8802-3/802.3 REVISION REQUEST

REQUESTED REVISION:
STANDARD: IEEE Std 802.3ab-1999
CLAUSE NUMBER: 40C.2.1 and Figure 40C-2
CLAUSE TITLE: Auto-Negotiation Transmit state machine add-on
for 1000BASE-T

Figure 40C-2 as modified by Revision requests 1042 to 1049 - Changes annotated

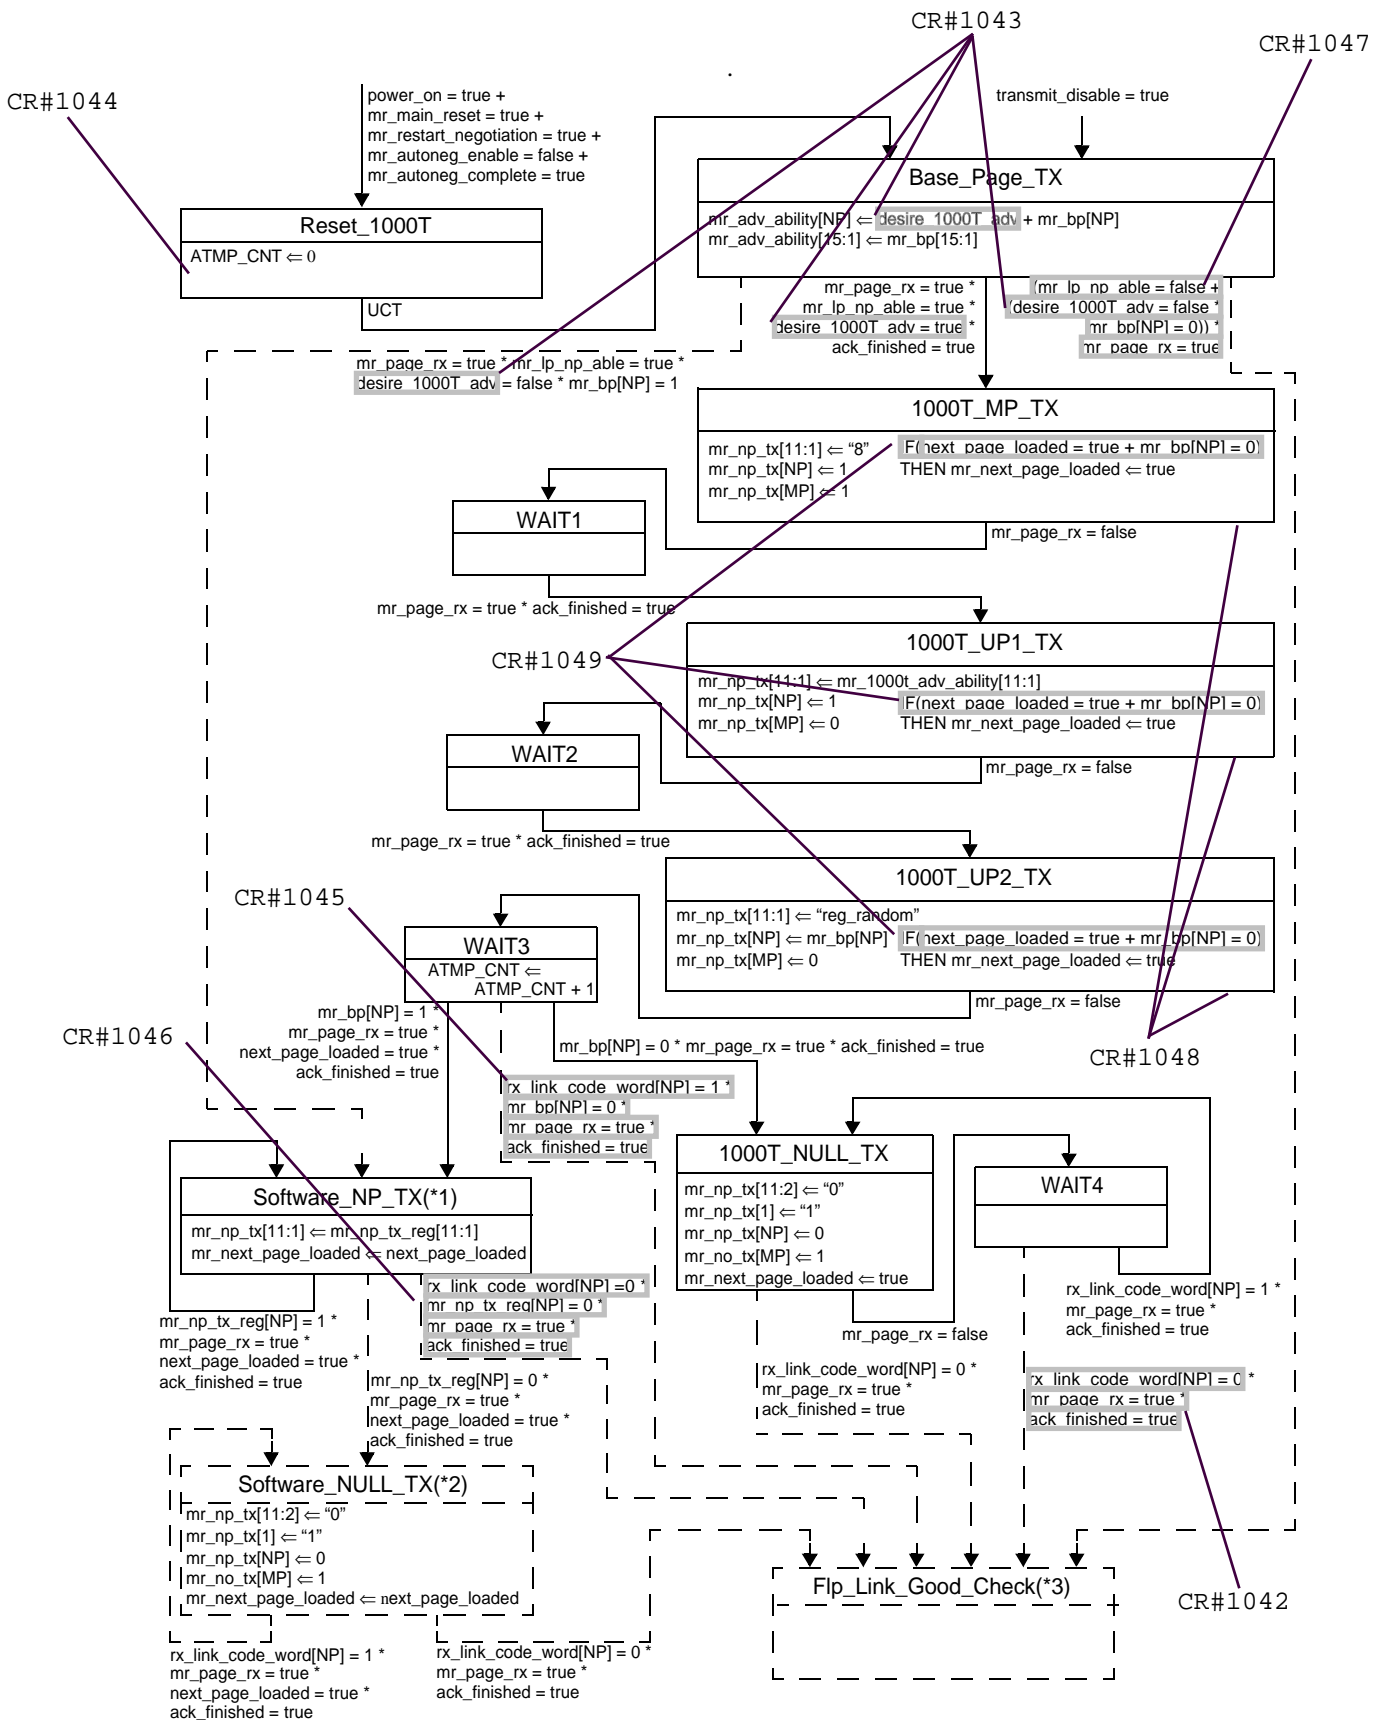
In Figure 40C-2 make a transition from Software_NP_TX directly to
Flp_Link_Good_Check with the following conditions:
rx_link_code_word[NP]=0 * mr_np_tx_reg[NP]=0 * mr_page_rx=true *
ack_finished=true.

To be precise, rx_link_code_word[NP]=1 should be added to the transition
conditions between Software_NP_TX and Software_NULL_TX.

The Software_NP_TX state does not have an exit directly to
Flp_Link_Good_Check. There will be circumstances in which a device will
not have to transmit a null message page.
